CSP 26-003KB (BP022) – ADDENDUM No.01
Gym Renovations and Additions

Fort Bend Independent School District
2023 Bond Program

Addendum Number One (01)
TO PLANS AND SPECIFICATIONS FOR
CSP 26-003KB BP022 Gym Renovations
Fort Bend ISD
STANTEC Project Nos.: 214001246

October 10, 2025

Project No. 214001246
Scale 1" = 20'-0"
Revision
Sheet 1 of 3
Drawing No. L100-HGES

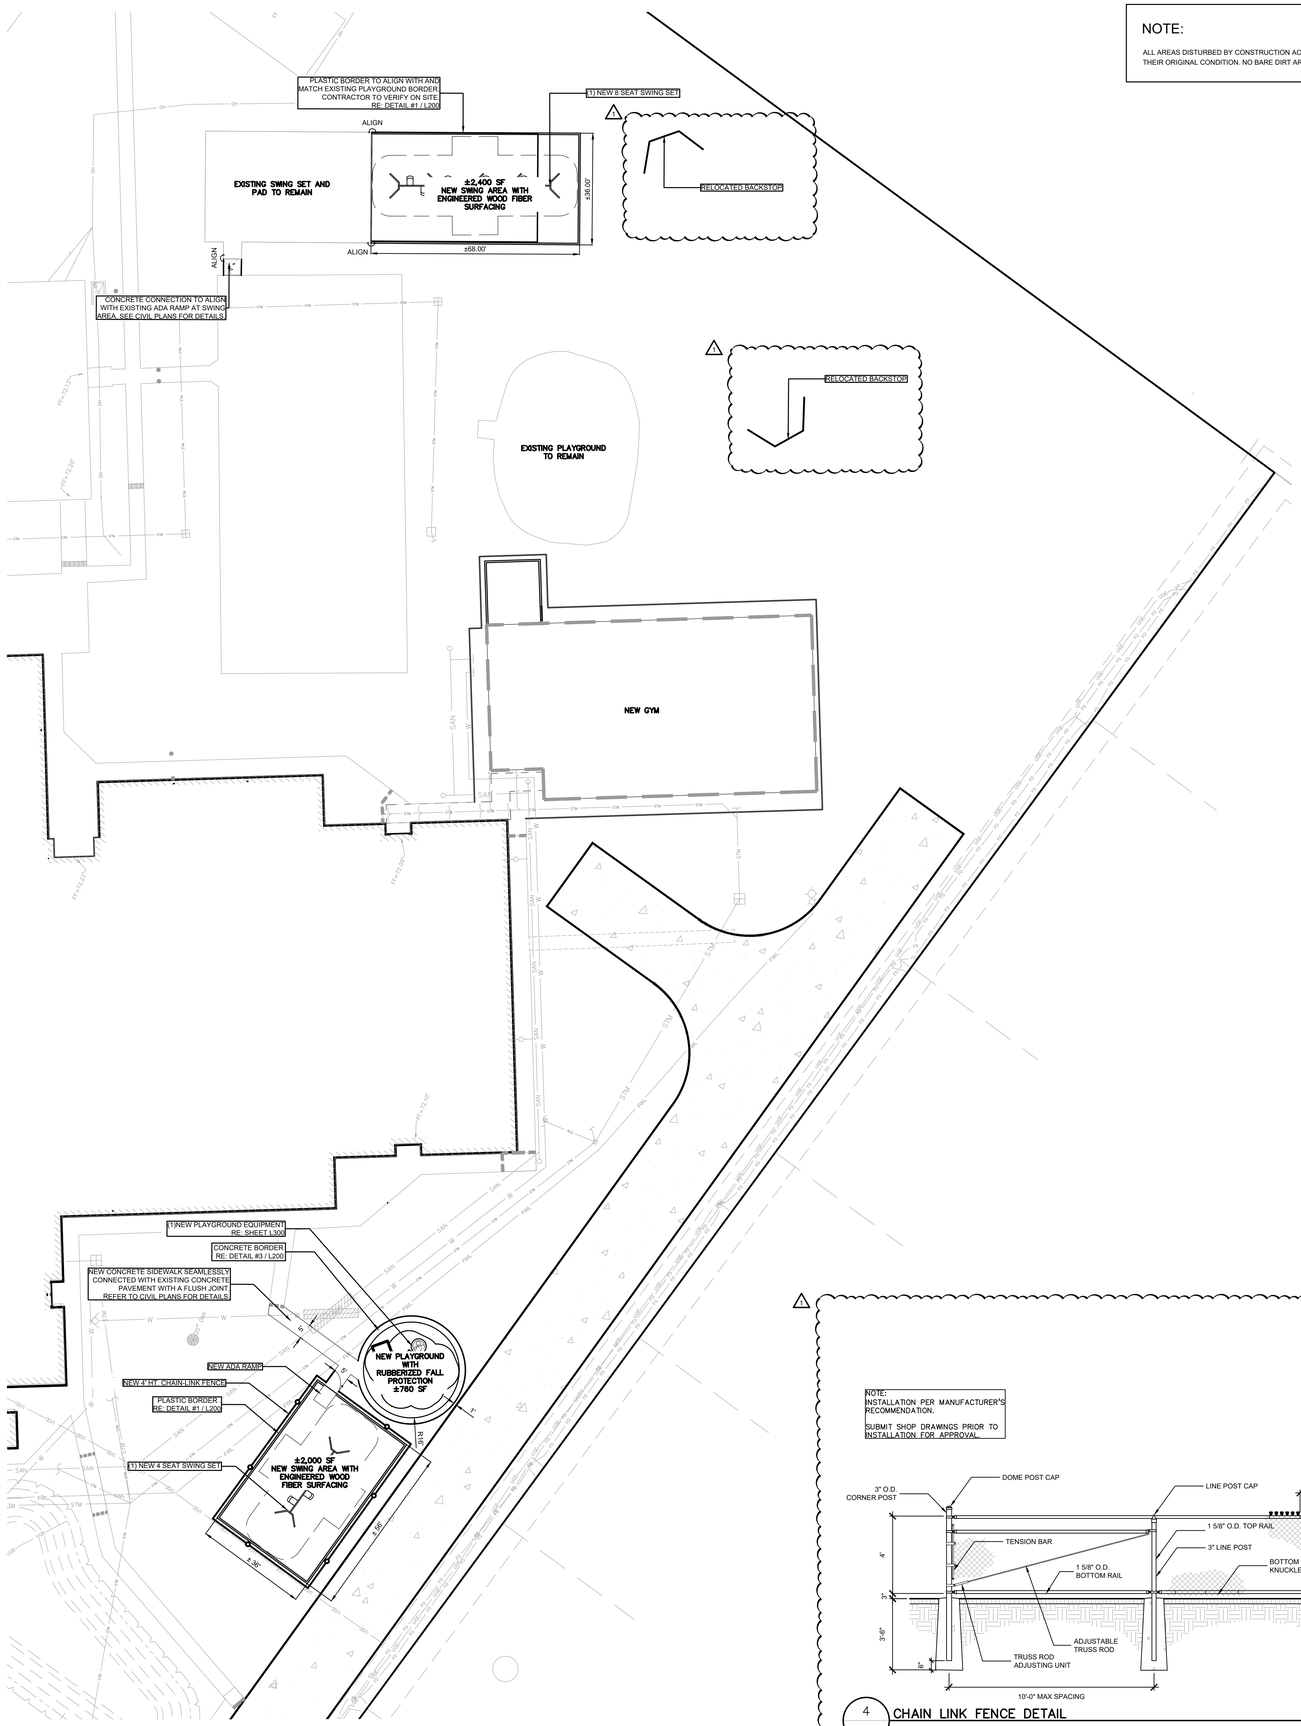
- **a. L100-HGES DEMOLITION PLAN**
  - i. UPDATED DRAWING TO SHOW DEMOLITION OF EXISTING BACKSTOP
- **b. L200-HGES- PLAYGROUND PLAN**
  - i. UPDATED DRAWING TO SHOW RELOCATED BACKSTOPS

1 PRESENTATION 3D VIEW - GYMNASIUM

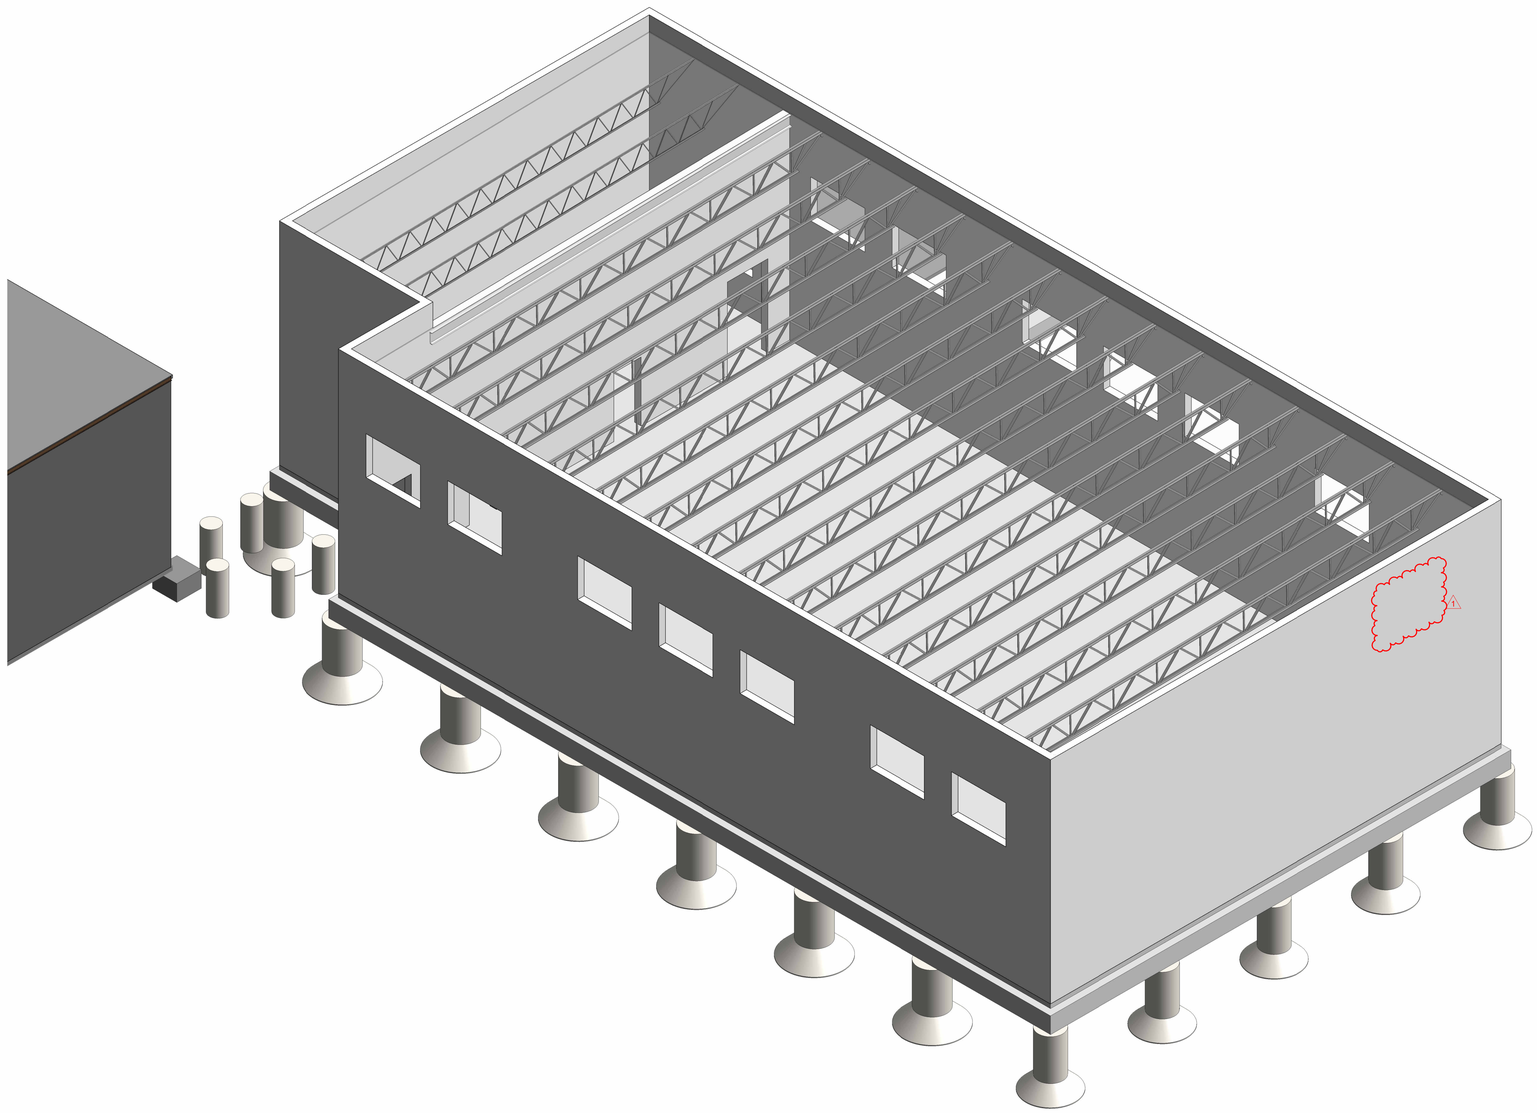
- **a. S001-HGES – 3D VIEW AND SHEET LIST**
  - i. 3D VIEW WAS UPDATED TO SHOW NO OPENING AT CMU WALL LOCATION.
- **b. S101-HGES – GENERAL STRUCTURAL CRITERIA**

1 ROOF FRAMING PLAN - GYMNASIUM
1/4" = 1'-0"

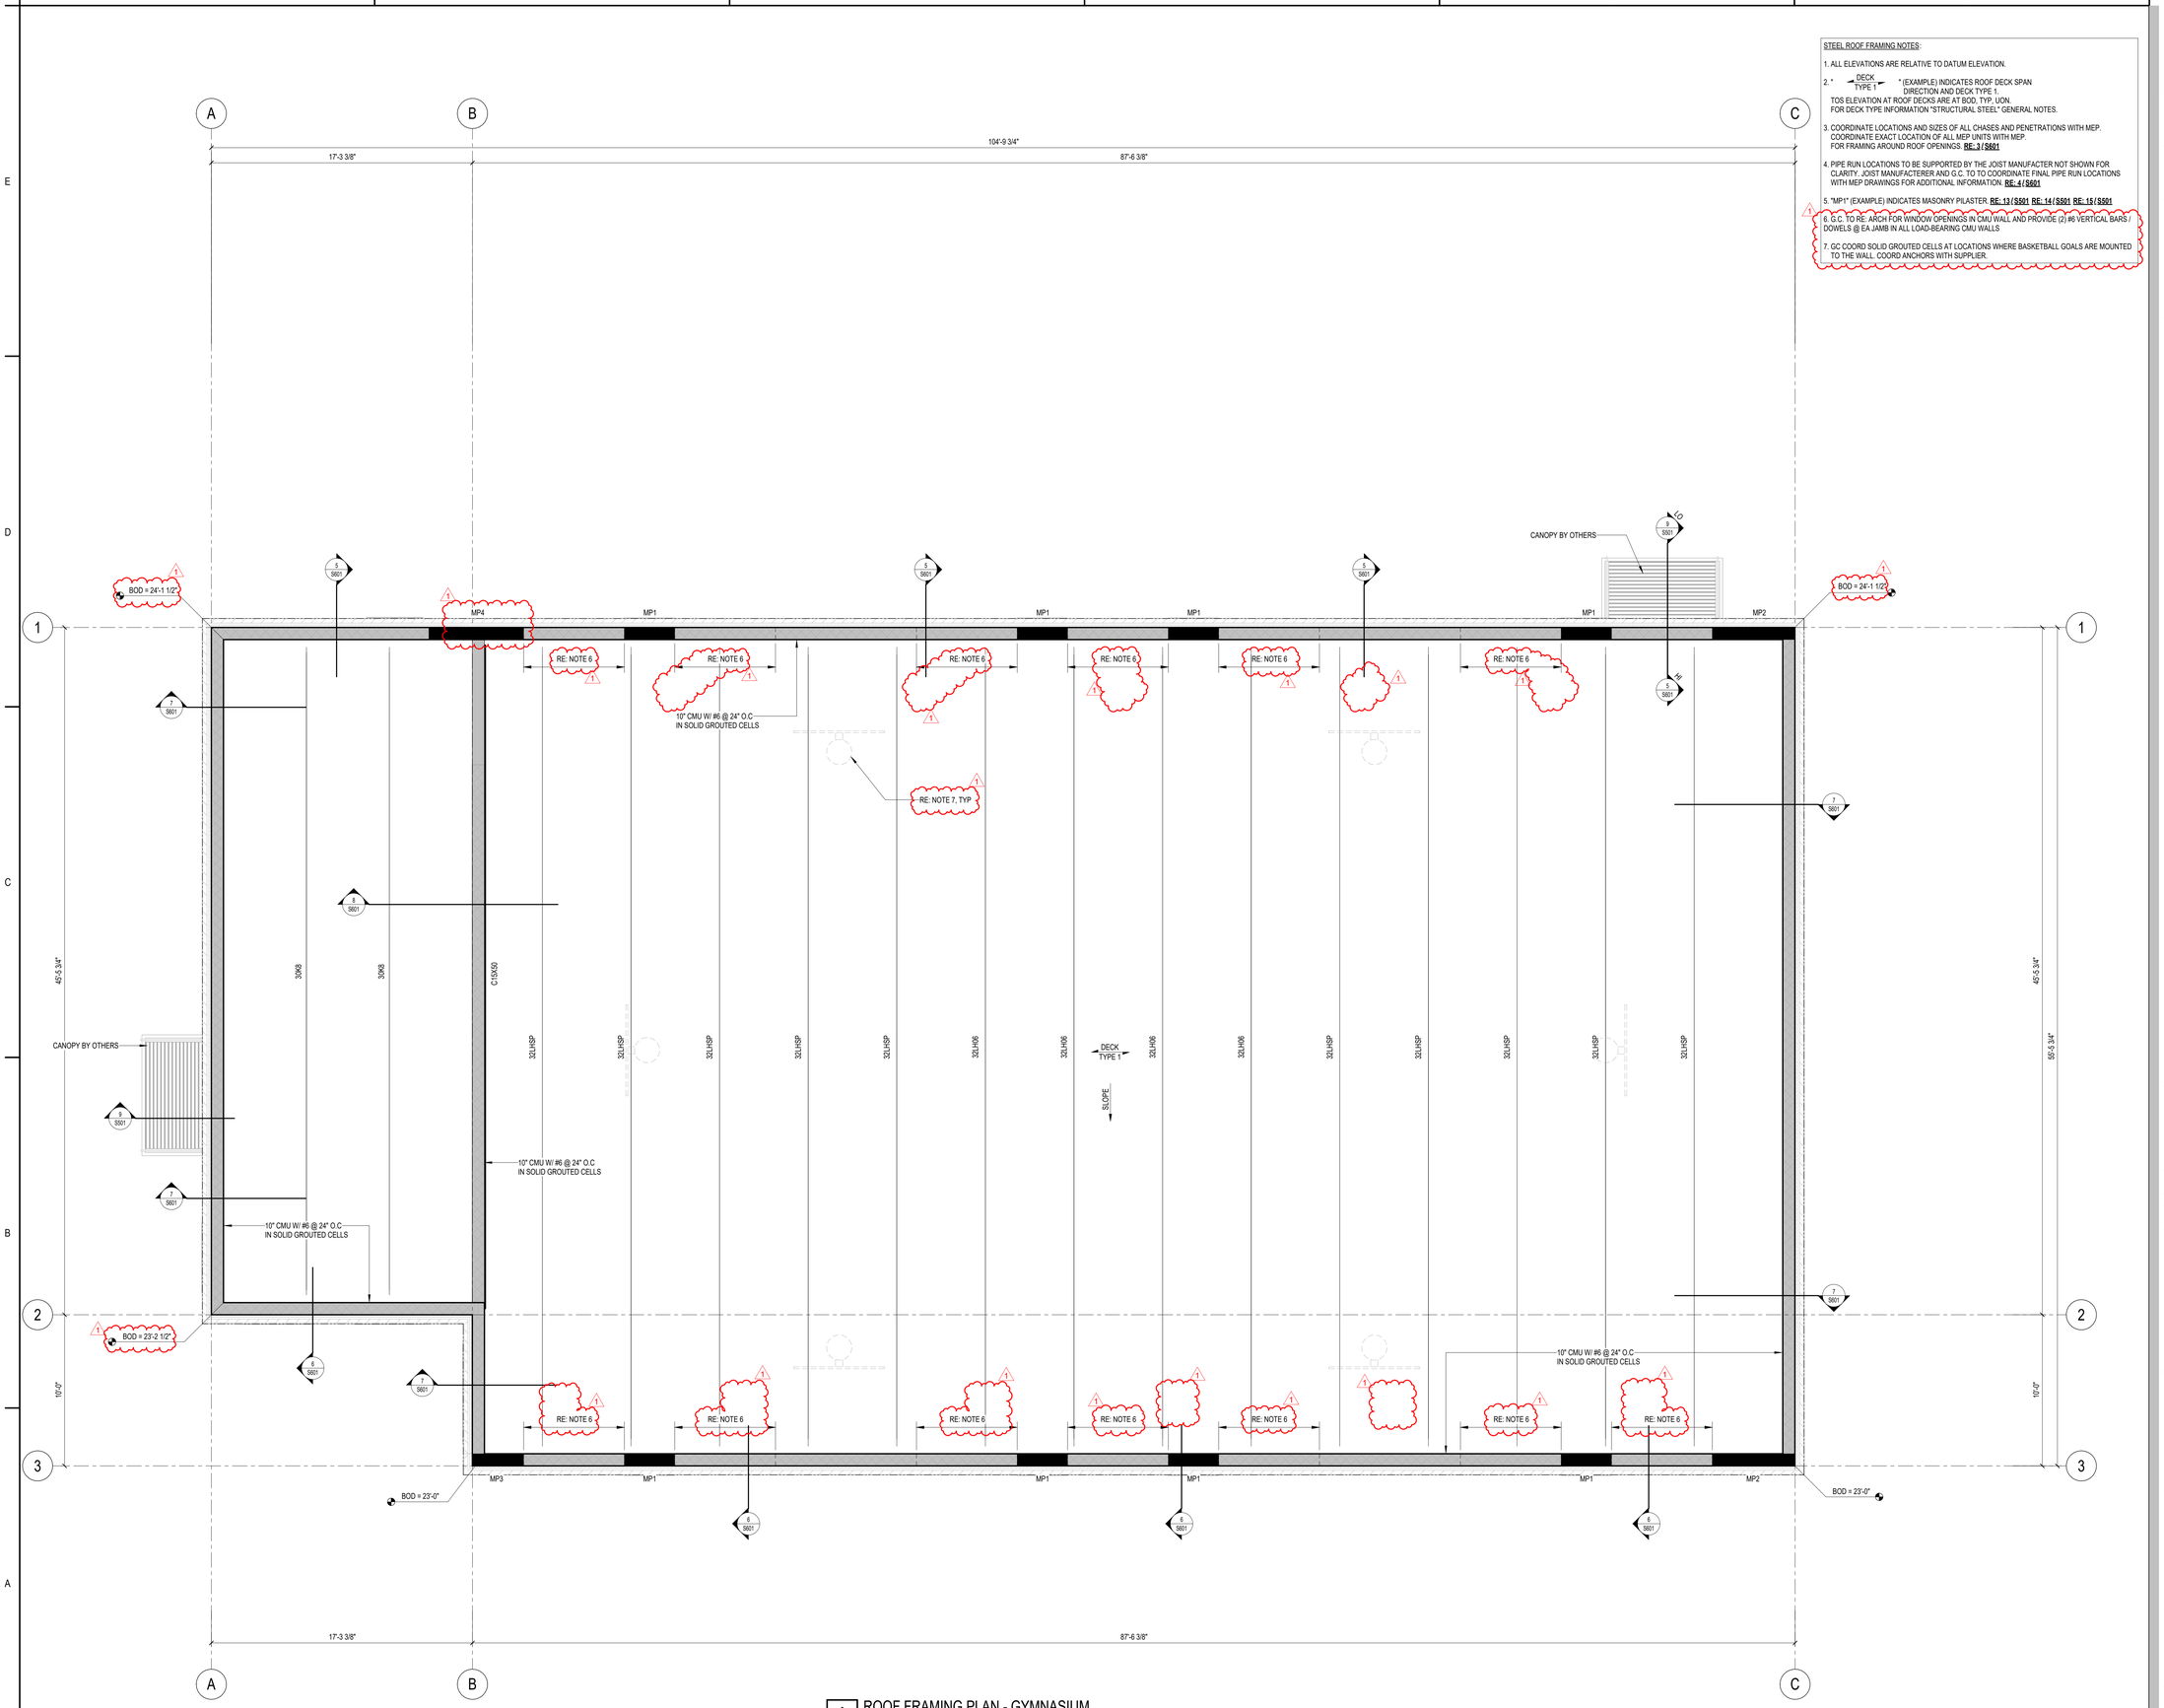
- v. MP4 NOTE WAS ADDED TO PLAN.
  - vi. NOTE 11 WAS ADDED TO PLAN AND FOUNDATION NOTES.
- **e. S202A-HGES-ROOF FRAMING PLAN - GYMNASIUM**
  - i. MP4 NOTE WAS ADDED TO PLAN.

- ii. NOTE 6 & 7 WERE ADDED TO PLAN AND FOUNDATION NOTES.
  - iii. DETAIL 12/S501 WAS REMOVED FROM PLAN.
  - iv. BOD WAS CHANGED TO 24' – 1 ½".
- **f. S402-HGES – SOG @ STRUCTURAL STEEL (GB/PIER)**

AD100 - HGES

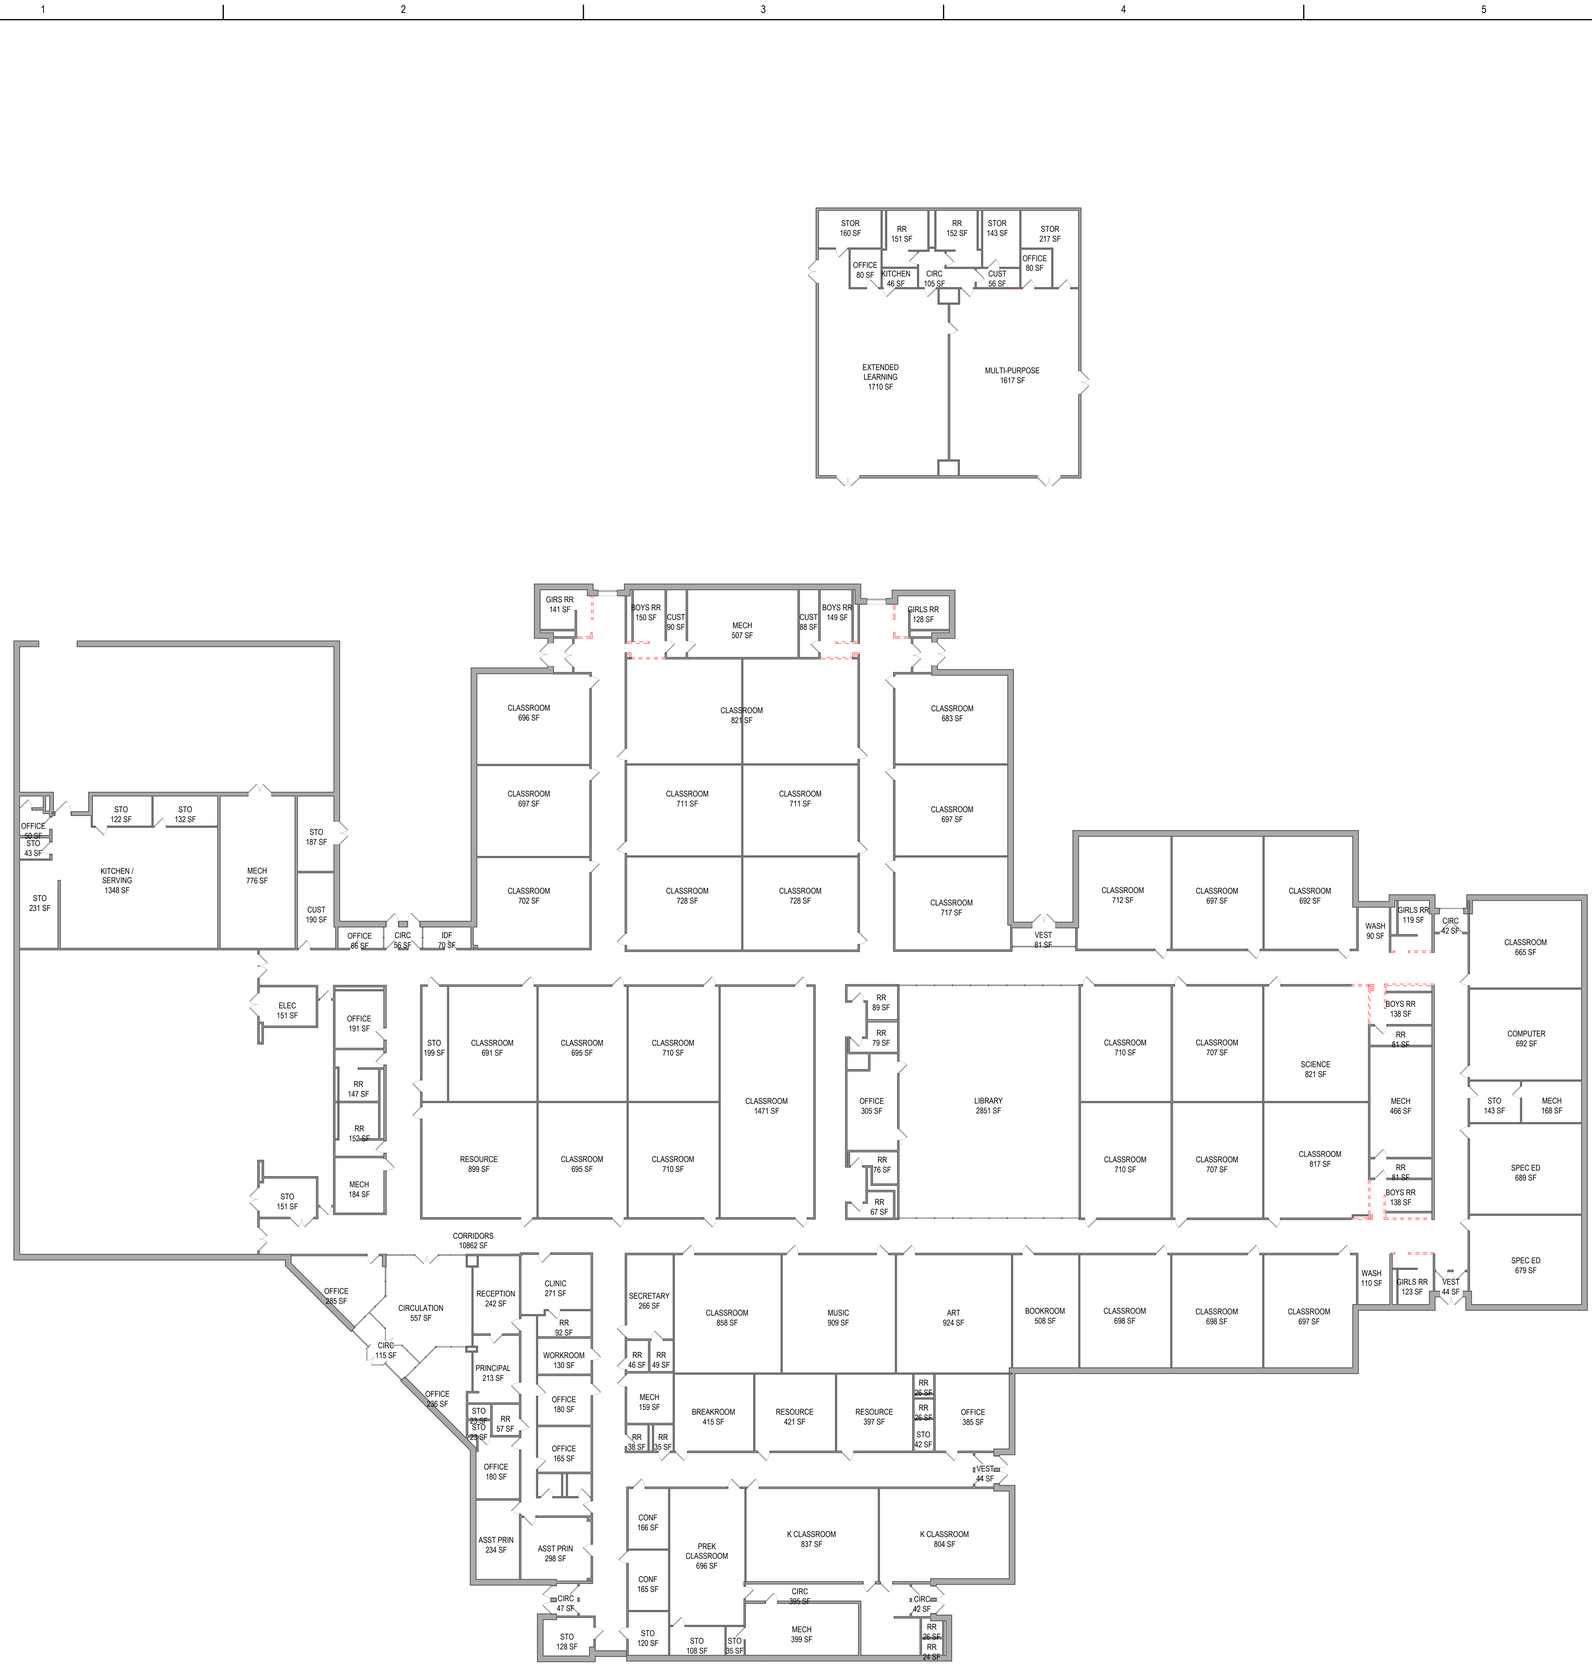
a. AD100 – HGES – ARCHITECTURAL DEMOLITION PLAN
- i. REMOVED LANGUAGE FROM NOTE 7 IN GENERAL DEMOLITION NOTES – GENERAL
- ii. ADDED NOTE "CONTRACTOR IS RESPONSIBLE FOR REMOVING ALL LOOSE EQUIPMENT FURNITURE AND FURNISHINGS IN ROOMS AFFECTED BY SCOPE OF WORK, PROVIDING BOXES FOR SUCH ITEMS AND MOVING THE EQUIPMENT, FURNITURE AND FIXTURES BACK AT THE END OF CONSTRUCTION."
